LONGLEAF GATES SUBDIVISION, PHASE TWO

APPLICATION NUMBER 10 DATE November 2, 2017
APPLICANT Longleaf Gates Subdivision, Phase Two
REQUEST Subdivision

SITE PLAN

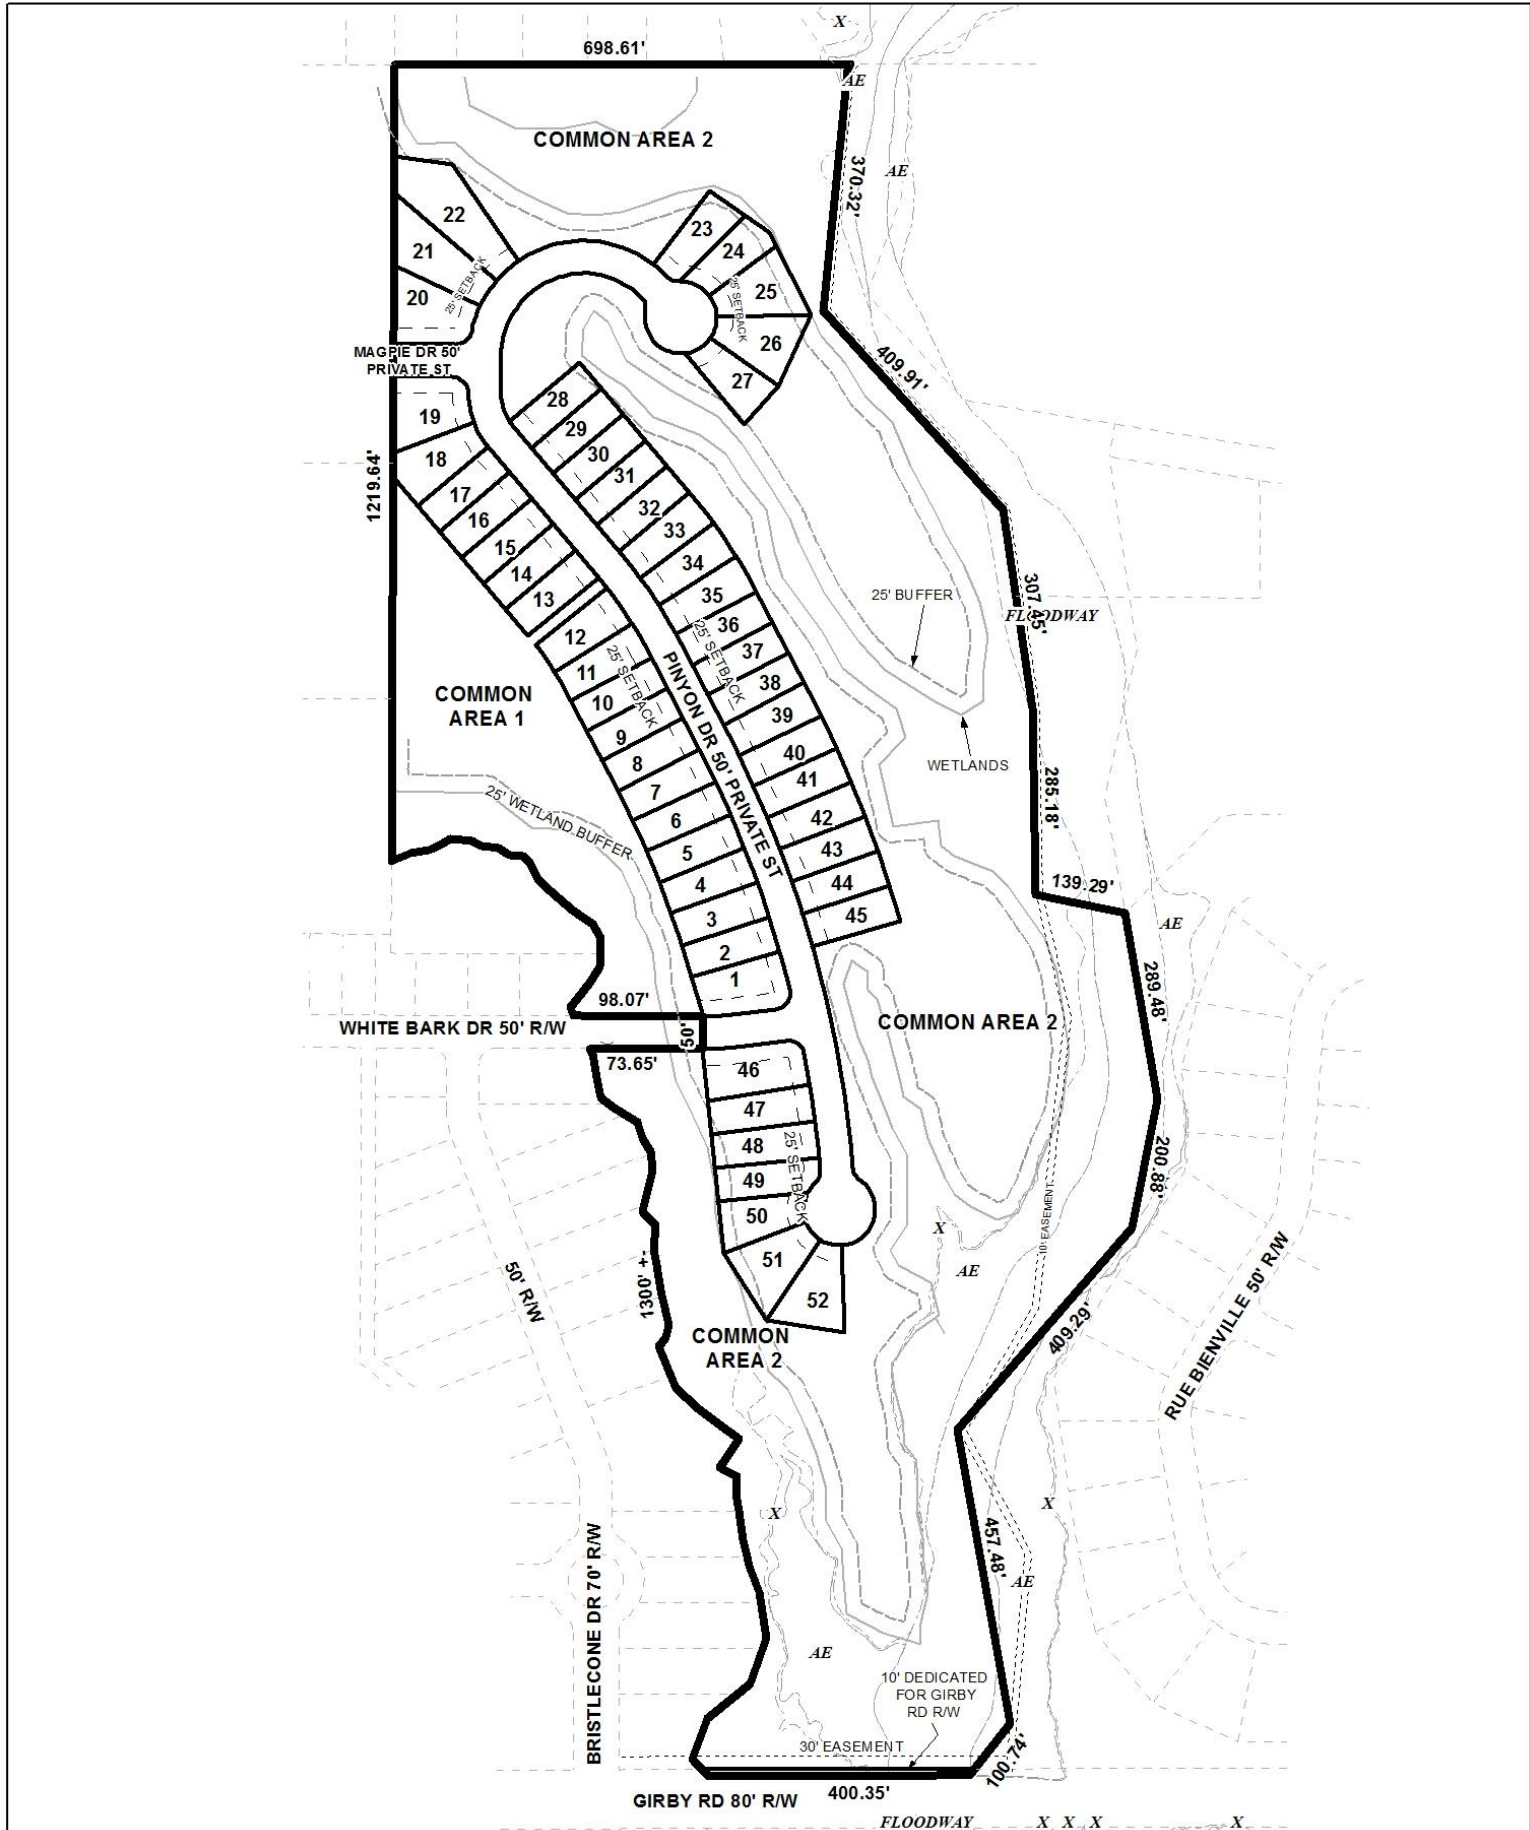
- E. Add street names to the vicinity map.
- F. Label Common Area 1 on sheet 1 of 2.
- G. Show and label all flood zones clearly. Existing information is drawn lightly.

- H. Show and label the MFFE (Minimum Finished Floor Elevation) on each lot that contains an AE, V, or X (shaded) flood zone designation.
- I. Provide the Surveyor's, Owner's (notarized), Planning Commission, and Traffic Engineering signatures.

The site has frontage on Girby Road, a planned major street with a 100' right-of-way requirement per the recently adopted Major Street Plan. The preliminary plat illustrates varying right-of-way widths at this location, but the plat illustrates an additional 10' of dedication to provide at least 50' from the centerline of Girby Road and is sufficient. This information should be retained on the Final Plat, if approved.

Proposed Lots 1 and 46 each have frontage on the proposed extension of Whitebark Drive, a private street with curb and gutter requiring a 50' right-of-way. Lots 1 and 46, as well as each of the remaining 50 proposed lots, also have frontage on Pinyon Drive, a proposed private street also requiring a 50' right-of-way. Sufficient rights-of-way are illustrated on the preliminary plat and should be retained on the Final Plat, if approved. Also, the labels indicating the proposed private street and street extension as private should be retained on the Final Plat, if approved.

The proposed private street is provided with cul-de-sacs at both terminuses in compliance with Section VIII.E.1.a. of the Subdivision Regulations; however, they do not appear to comply with Section V.B.14. regarding the required 120' turnaround right-of-way diameter. The plat should be revised to illustrate compliant turnaround rights-of-way for both proposed cul-de-sacs, if approved.

The proposed lots meet the minimum size requirements for lots served by public water and sanitary sewer systems; however, while lot sizes are provided in square feet on the preliminary plat, they are not provided in acres. As such, revision of the plat to depict the sizes of each lot in both square feet and acres should be required; or, provision of a table on the Final Plat providing the same information may suffice.

Two common areas are provided on the preliminary plat, to include a detention area between proposed Lots 27 and 28, and are labeled with their sizes in acres. The plat should be revised to also provide their sizes in square feet; or, provision of a table on the Final Plat providing the same information may suffice. A note should also be provided on the Final Plat stating that the maintenance of all common areas, including the detention area, is the responsibility of the property owners.

The 25' minimum building setback line is not illustrated along Girby Road, but it is illustrated along the frontages of all proposed lots and a note on the plat iterates this requirement; however, the line itself is not labeled. As such, revision of the plat to illustrate the 25' minimum building setback line along Girby Road and label the 25' minimum building setback line along the remaining lots should be required, if approved.

Regarding access management, a note should be placed on the Final Plat stating each lot and common area is limited to one curb cut, with any changes in their sizes, locations, or designs to be approved by Traffic Engineering and conform to AASHTO standards. An additional note denying direct access to Common Area 2 from Girby Road should also be provided on the Final Plat, if approved.

Multiple easements are illustrated on the plat, including a 10' sanitary sewer easement along the East property line and a 30' sewer easement along Girby Road. A note stating a 10' drainage and utility easement is dedicated along the frontage of all proposed lots and along lot lines abutting a right-of-way is also provided. As such, if approved, an additional note should be required on the Final Plat stating no structures shall be constructed in any easement.
